E326: EPA17-24 and CARB24 PACCAR MX Fuel Injector Connector Upgrade

E326

3/11/2025

Broken Injector Connectors in Valve Train Casing Assembly

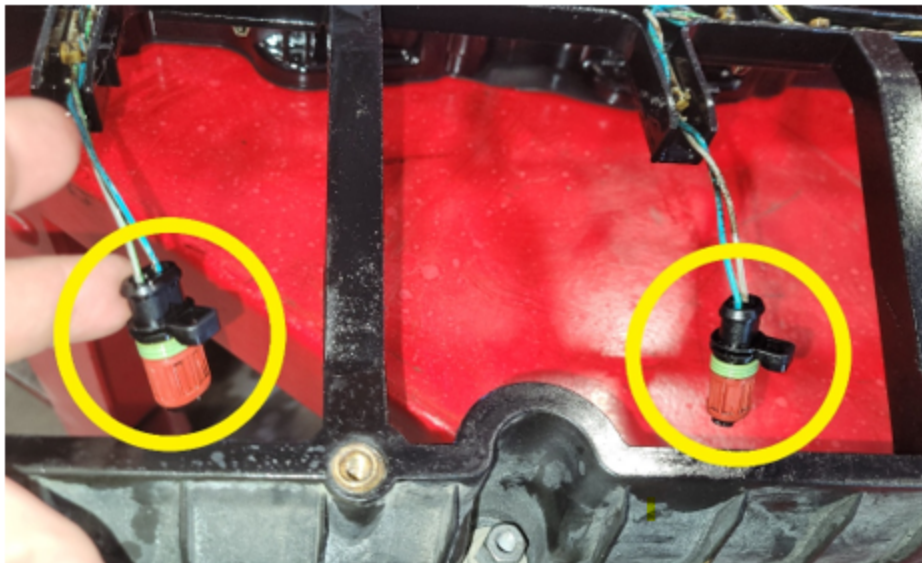
During repairs which involve disconnecting the injectors or removing the valve train casing, the injector connector shells (1439888PE) locking tabs may be broken. Since the injector connector shells were not

previously available, the entire valve train casing assembly had to be replaced to fix the issue.

Injector connector shell locking tabs may break when disconnected, resulting in valve train casing assembly replacement.

To prevent downtime, dealers should stock the injector connector shells (1439888PE). Replacement of broken connector shells should occur rather than replacement of the valve train casing assembly.

Injector connector shell replacement procedures can be found in RMI by searching “valve train casing”, then select Parts > Valve train casing > Jobs > replace 1 (one) connector 2-pin (Basic assembly).

When connector shells are replaced according to RMI, a pin extraction tool is required to complete the repair. This tool is part number 539972-1, available through PACCAR Parts.
